From: Bloomsbury Association
Sent: 25 September 2023 12:51
To: Planning Planning
Cc: David Fowler; Chair Association
Subject: APPLICATION FOR PLANNING PERMISSION 2023/2510/P & 2023/2653/L - 1 MUSEUM STREET
Attachments: SUBMISSION STRUCTURE_3.pdf; 8 OPEN SPACE AND PUBLIC REALM.pdf

**SELKIRK HOUSE, 166 HIGH HOLBORN, 1 MUSEUM STREET, 10-12 MUSEUM STREET, 35-41 NEW OXFORD STREET & 16A-18 WESTCENTRAL STREET
LONDON WC1A 1JR**

Application for planning permission reference: 2023/2510/P

Application for listed building consent: 2023/2653/L

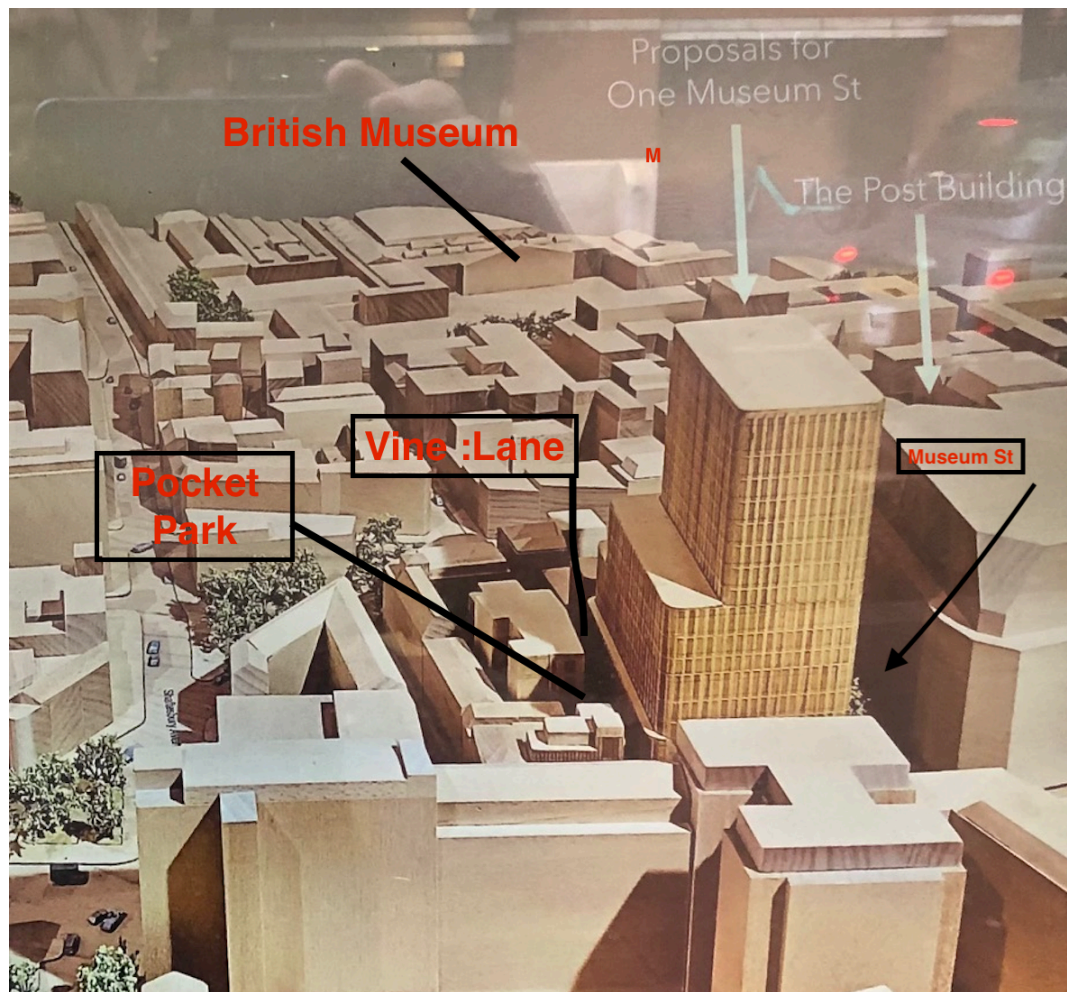
8.3.2.16 The accompanying image below is of the developer's model of their scheme. The dingy nature of Vine Lane is all too apparent and is shown to be overwhelmed by the proposed tower block adjacent, and by the residential block alongside the west side, backing onto Grape Street's existing residential accommodation. As the model shows, the daylight and sunlight penetration to both Vine Lane, the 'pocket park' and Museum Street will be miserable, and certainly the development public realm around the tower block will not be attractive and welcoming spaces.
